TOSHIBA Original CMOS 4-Bit Microcontroller

TMP47P241VNG

TMP47P241VMG

Document Change Notification

SDIP28-P-400-1.78

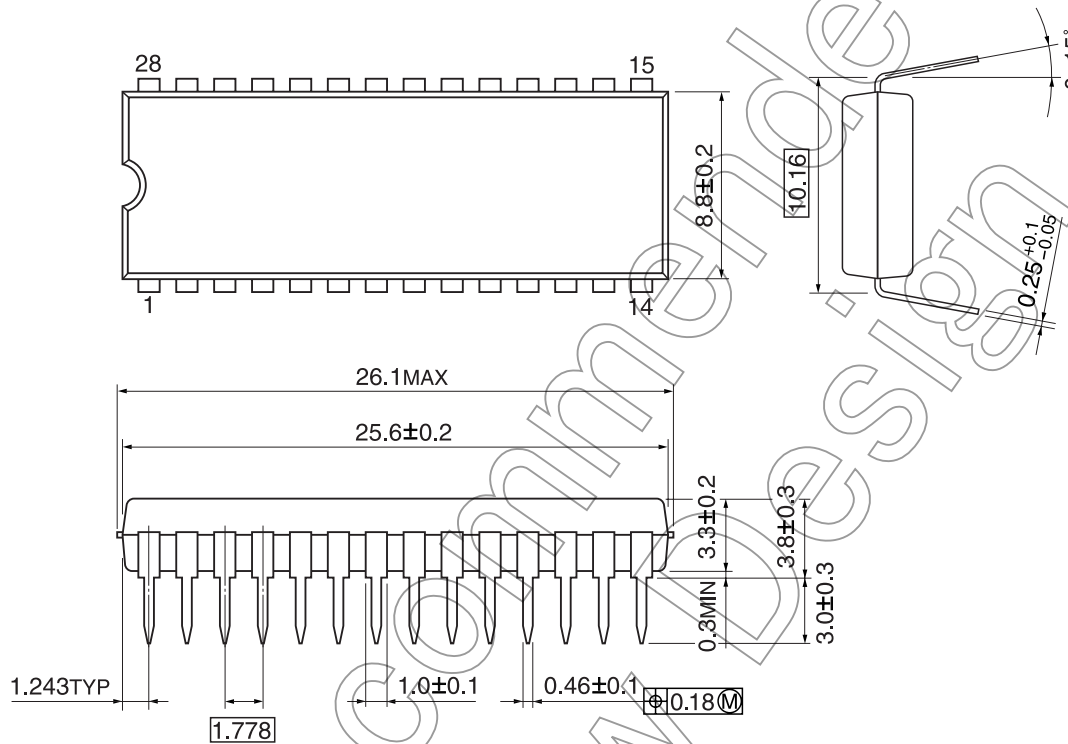
1. Part number
2. Package code and dimensions

Previous Part Number (in Body Text)	Previous Package Code (in Body Text)	New Part Number	New Package Code	OTP
TMP47P241VN	P-SDIP28-400-1.78	TMP47P241VNG	SDIP28-P-400-1.78	—
TMP47P241VM	P-SOP28-450-1.27	TMP47P241VMG	SOP28-P-450-1.27B	—

*: For the dimensions of the new package, see the attached Package Dimensions diagram.
